UNITED STATES PATENT AND TRADEMARK OFFICE

Office Action Summary

10/686,097

DETAILED ACTION

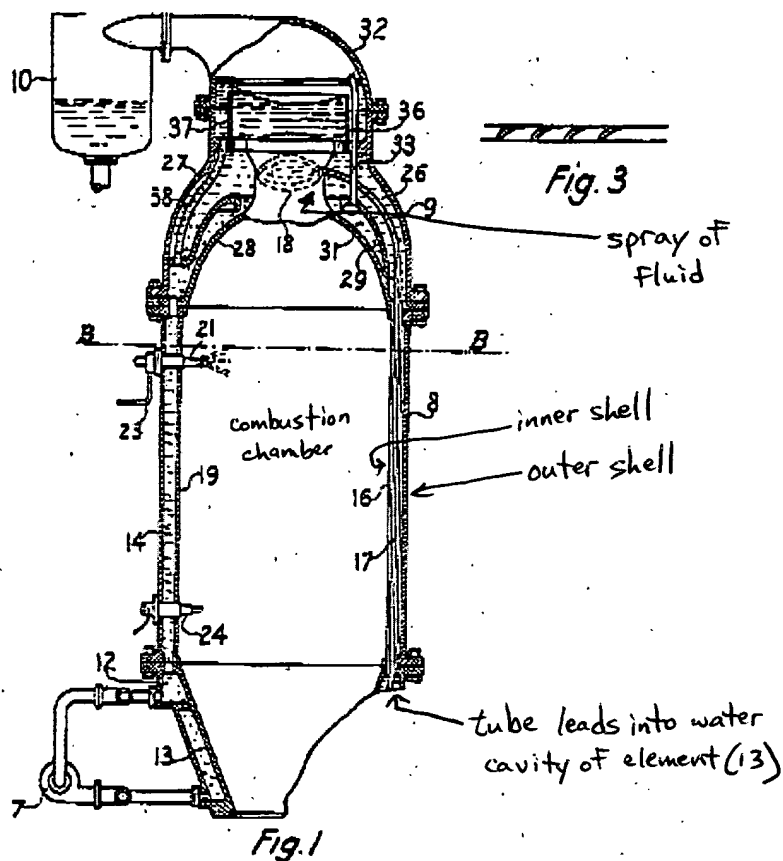
Claims 1, 2, 3, 5, 36, 40, 42-45, 47-52, and 56-58 are rejected under 35 U.S.C. 102(b) as being anticipated by **Noack (1,948,940)**. **Noack** discloses a steam (vapor) generator and includes a combustion chamber, an outer structure (14) surrounding the combustion chamber wherein a cavity is located between the combustion chamber and the outer structure, a water inlet (13) located in the outer structure and receives water into the cavity from an inherent water supply (shown by tube (26?) extending into water inlet portion 13), a water conduit (16?, not accurately shown) coupling the cavity to a water injection element (see element 18) so that water can be introduced into the combustion chamber from the cavity. The combustion chamber and the outer structure constitute the first and second cylindrical element wherein the structures are tapered at each end. The combustion chamber furthermore includes an ignition inlet (24) extending into the combustion chamber located at one end, a fuel inlet (23) for providing fuel to the combustion chamber, an air inlet (which is inherent to cause combustion and is well known to be provided by a blower source) at the same end as the fuel & ignition inlet ends, and a vapor outlet (32) extending out of

the combustion chamber and at an opposing end. SEE Figure for clarification of claimed elements.
